QUALITY ASSURANCE -- NON-CONFORMANCE REPORT

Report No: NCR-000271

Reference Description: Missed MT Indications by QC, Welds SEG2A-033 and 034

Job Name: SAS Superstructure

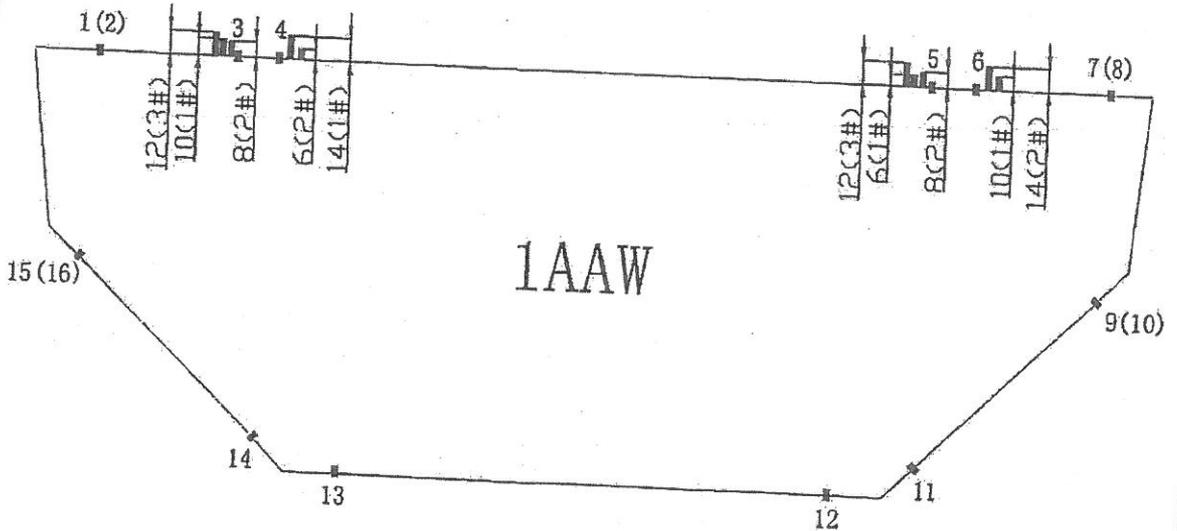
吊耳去除后母材上发现有10处横向裂纹。1、L=10mm; 2、L=8mm; 3、L=12mm; 4、L=14mm; 5、L=6mm; 6、L=6mm; 7、L=8mm; 8、L=12mm; 9、L=10mm; 10、L=14mm;

Ten transverse cracks were found by use of MT in material after removing lifting.

- 1. The tack crack was caused during assembly lifting, and cracks extended to base metal after removing lifting.
- 2. Welding contraction stresses and insufficient preheat and post heat control caused the crack.

- 1. 采用打磨的方式去除裂纹;
 - 2. 准备一个正确的接头型式, 具体参照相应的返修WPS;
 - 3. VT和MT检测确认返修区域没有裂纹;
 - 4. 根据批准的返修焊接工艺规程
 - 5. 预热温度应不小于100℃,
 - 6. 预热范围在修补区域周围不应小于150mm;
 - 7. 将修补区域打磨与母材或相邻焊缝平齐;
 - 8. 对修补区域做VT与MT检测.
- 1. Remove the crack by means of grinding.
 - 2. Prepare excavation according to the approved repair WPS.
 - 3. Verify with VT and MT repair areas are crack free.
 - 4. Preheat and weld according to the approved repair WPS.
 - 5. Preheat prior to welding to a minimum temperature of 100°C
 - 6. The preheat area shall be a minimum of 150mm in all directions around the repair area.
 - 7. Grind the repaired area flush with base metal or the adjacent weld.
 - 8. Perform VT and MT of the repair areas.

- 加强装配和焊接时监控和控制, 减少点焊裂纹;
 - 在焊后严格控制其后热程序, 避免裂纹现象发生。
- Enhance supervision and controlling during assembly and welding to reduce tack welding cracks.
 - Enhance supervision during the post heating operation to avoid cracks.

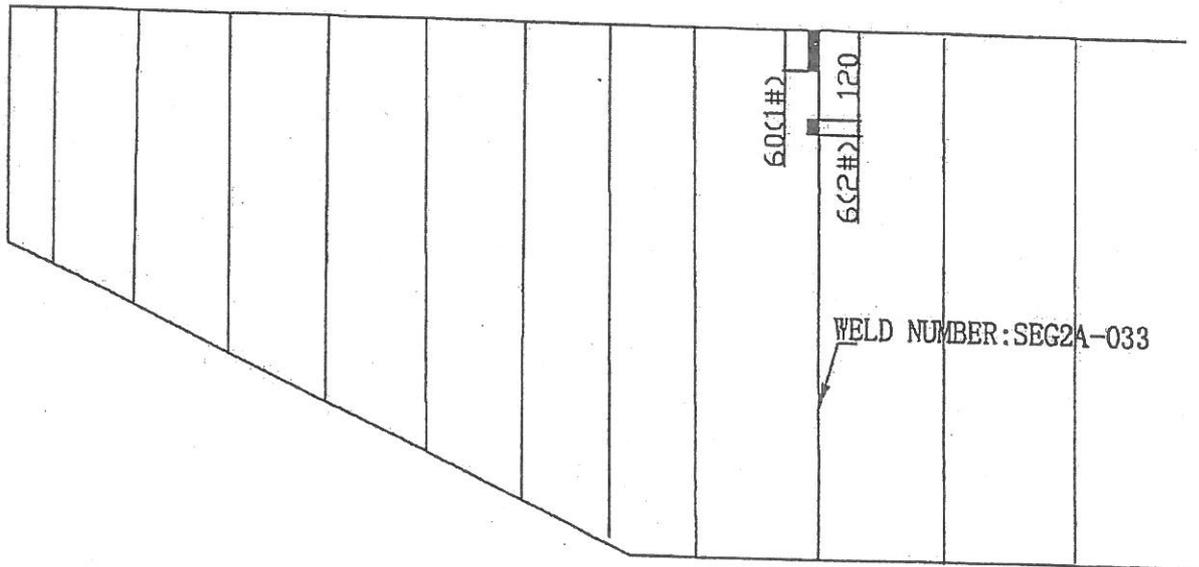
在对SEG2A-033检测时, 发现2处纵向裂纹, 1、L=60mm; 2、L=6mm.

We found two longitudinal cracks in SEG2A-033.

1. 火焰加热时, 水汽没有完全的去掉或者这个区域预热不够;
1. Moisture wasn't completely removed during drying operation (preheating) or the area wasn't preheated sufficiently.

1. 采用打磨的方式去除裂纹;
 2. 准备一个正确的接头型式, 具体参照相应的返修WPS;
 3. VT和MT检测确认返修区域没有裂纹;
 4. 根据批准的返修焊接工艺规程
 5. 预热温度应不小于100℃;
 6. 预热范围在修补区域周围不应小于150mm;
 7. 将修补区域打磨与母材或相邻焊缝平齐;
 8. 对修补区域做VT与MT检测。
1. Remove the crack by means of grinding.
 2. Prepare excavation according to the approved repair WPS.
 3. Verify with VT and MT repair areas are crack free.
 4. Preheat and weld according to the approved repair WPS.
 5. Preheat prior to welding to a minimum temperature of 100°C
 6. The preheat area shall be a minimum of 150mm in all directions around the repair area.
 7. Grind the repaired area flush with base metal or the adjacent weld.
 8. Perform VT and MT of the repair areas.

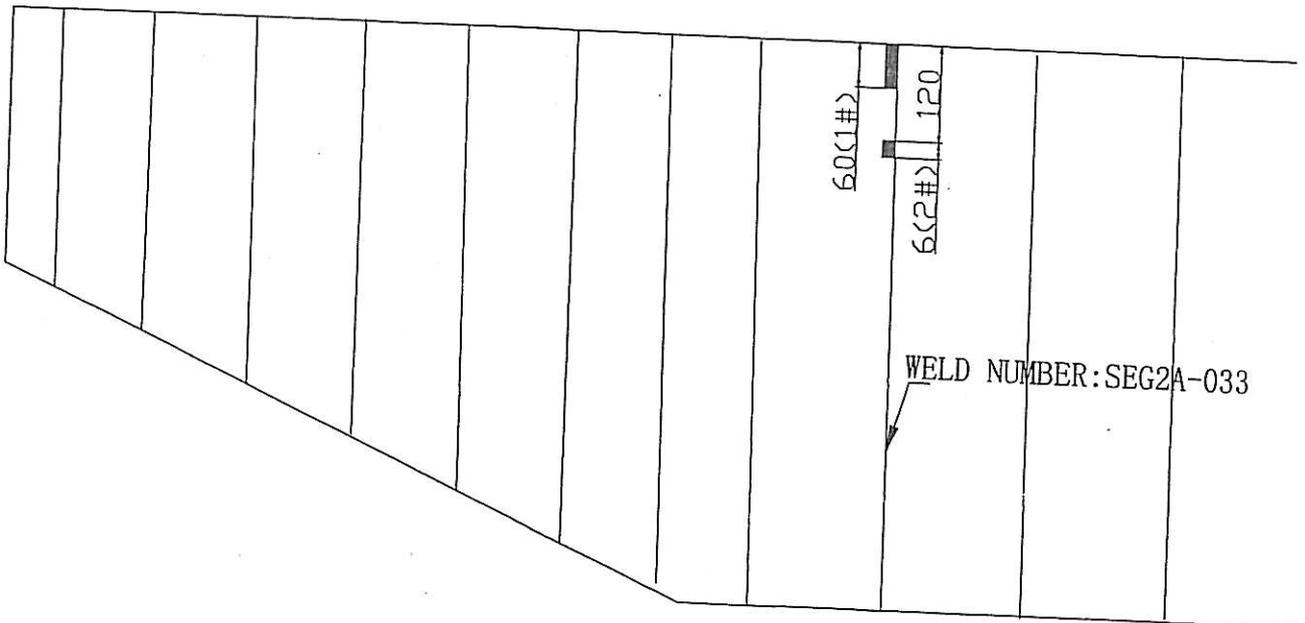
在对SEG2A-033检测时, 发现2处纵向裂纹。1、L=60mm; 2、L=6mm.

We found two longitudinal cracks in SEG2A-033.

1. 火焰加热时, 水汽没有完全的去掉或者这个区域预热不够;
1. Moisture wasn't completely removed during drying operation (preheating) or the area wasn't preheated sufficiently.

1. 采用打磨的方式去除裂纹;
 2. 准备一个正确的接头型式, 具体参照相应的返修WPS;
 3. VT和MT检测确认返修区域没有裂纹;
 4. 根据批准的返修焊接工艺规程
 5. 预热温度应不小于100℃,
 6. 预热范围在修补区域周围不应小于150mm;
 7. 将修补区域打磨与母材或相邻焊缝平齐;
 8. 对修补区域做VT与MT检测。
1. Remove the crack by means of grinding.
 2. Prepare excavation according to the approved repair WPS.
 3. Verify with VT and MT repair areas are crack free.
 4. Preheat and weld according to the approved repair WPS.
 5. Preheat prior to welding to a minimum temperature of 100°C
 6. The preheat area shall be a minimum of 150mm in all directions around the repair area.
 7. Grind the repaired area flush with base metal or the adjacent weld.
 8. Perform VT and MT of the repair areas.

1. QC shall verify sufficient preheat has been applied, to remove moisture, prior to welding.
